RE: Hammond River Holdings Response to Technical Review Committee (TRC)
Questions and Comments – Proposed Upham East Gypsum Quarry, EIA Registration
Document File No. 4561-3-1508

Table 1: Summary of Responses to TRC Questions Regarding the Proposed Upham East Gypsum Quarry, Upham, New Brunswick

FISH HABITAT
FIGURE 5.4.1

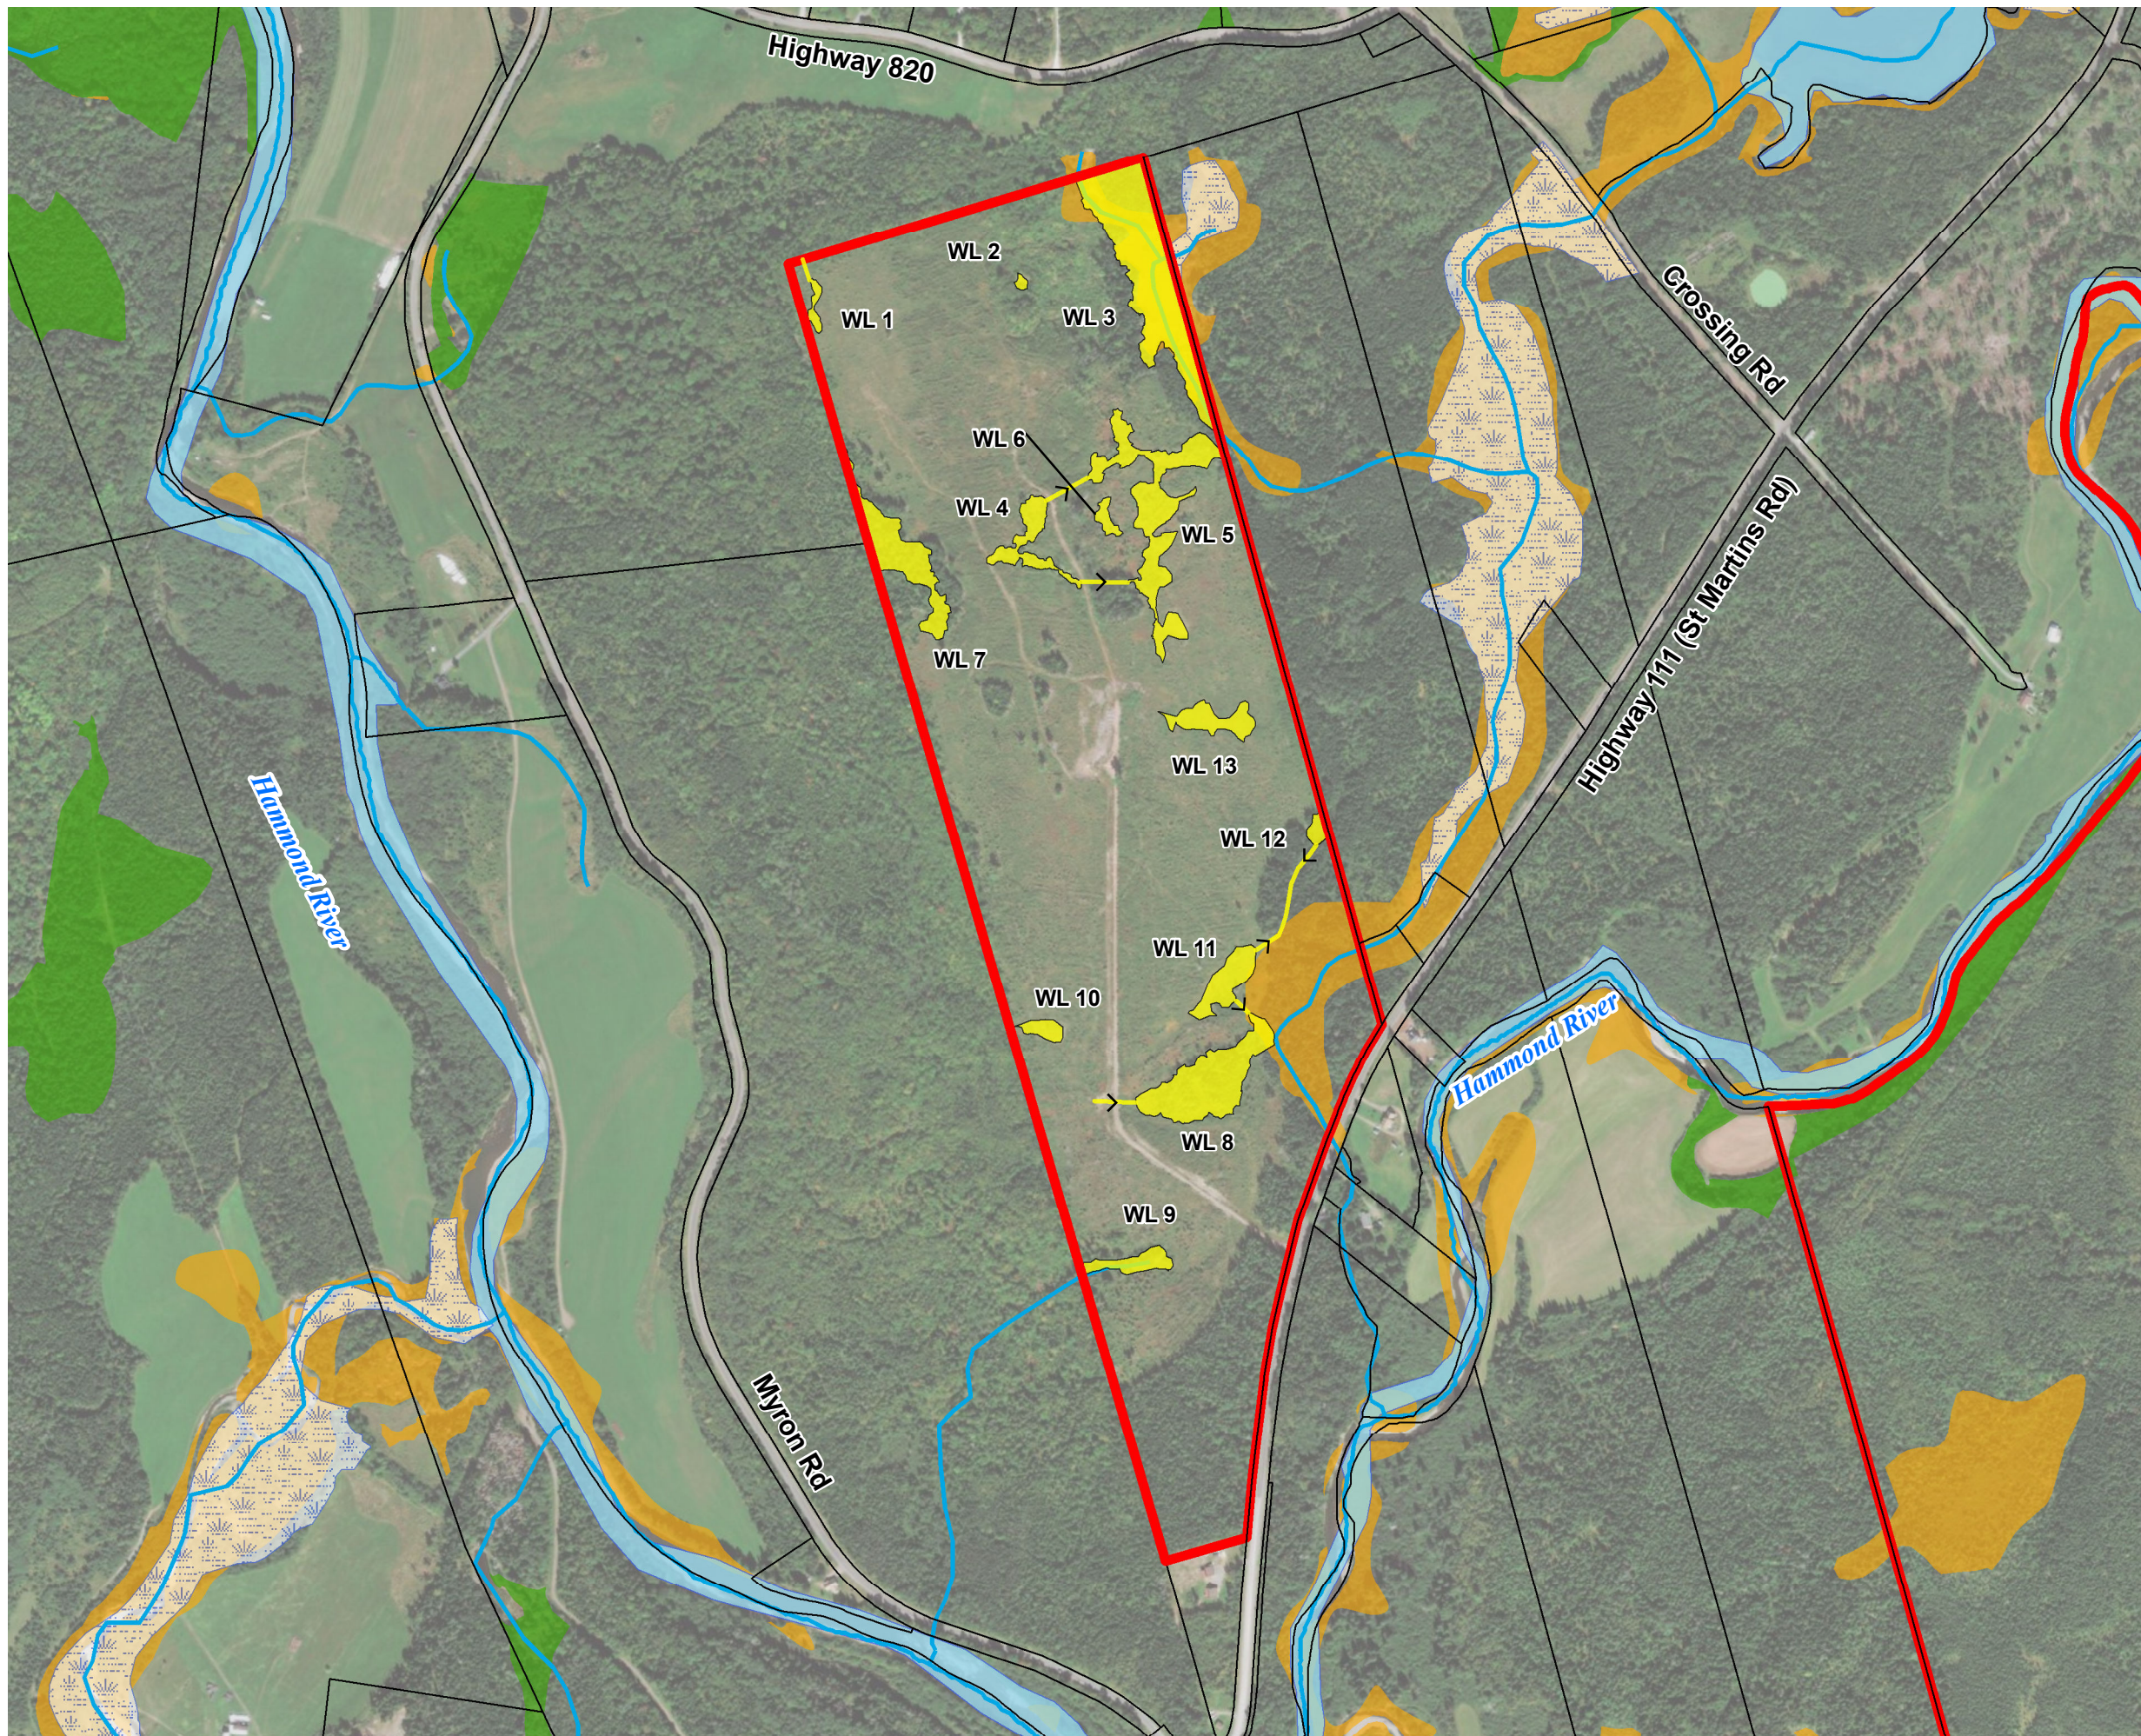
77	<p>Can you please provide the expected footprint of the loss for the watercourse in relation to their existing dimensions?</p>	<p>Based on the existing dimensions (average bankfull widths and lengths of the watercourses), the expected footprint of the fish habitat loss within WC1 is approximately 1,000 m². An authorization under Section 35(2) of the Fisheries Act with appropriate offsetting, as well as a WAWA permit, will be obtained for the loss of fish habitat in WC1.</p> <p>WC2 is not fish habitat as there is no defined channel. Regardless, the intention is to maintain the current vegetation buffer surrounding WC2 and thus keeping it unaltered. Authorization</p>

Comment/ Question No.	Question/Comment from Technical Review Committee (TRC)	Hammond River Holdings' Response
		<p>136 m²), which will require authorization and offsetting under the Fisheries Act as well as a WAWA permit. Revised Figures 5.4.1 and 5.5.1 are attached, and will be further corrected in the erratum.</p> <p>An authorization under Section 35(2) of the Fisheries Act with appropriate offsetting, as well as a WAWA permit, will be obtained for alterations to WC1 and WC4.</p>
78	<p>Can you please provide details on how the watercourses will be impacted by the construction of the open-pit quarry? Will the watercourses be removed/diverted outside of the PDA or altered in terms of excavation or infilling?</p>	<p>Please refer to the response to Question #77 above. As described in the EIA Registration, impacts to WC1 and WC4 are expected to occur, while the other watercourses can be avoided.</p> <p>Only two watercourses (WC1 and WC3) that are considered fish habitat on the Project site have water present year-round. Though identified as a watercourse based on the GeoNB mapping, WC2 was determined to not be fish habitat during the August 2018 field survey as there was no defined channel or water present. WC4 was identified during the field survey as a field-identified ephemeral watercourse, but had no water present during surveys conducted in August 2018. Further information is presented in Section 5.4.2.3 of the EIA Registration.</p> <p>An authorization under Section 35(2) of the Fisheries Act with appropriate offsetting, as well as a WAWA permit, will be obtained for alterations to WC1 and WC4, as required. These approval processes inherently consider the specific details of the alterations to ensure measures are taken to minimize impacts.</p>
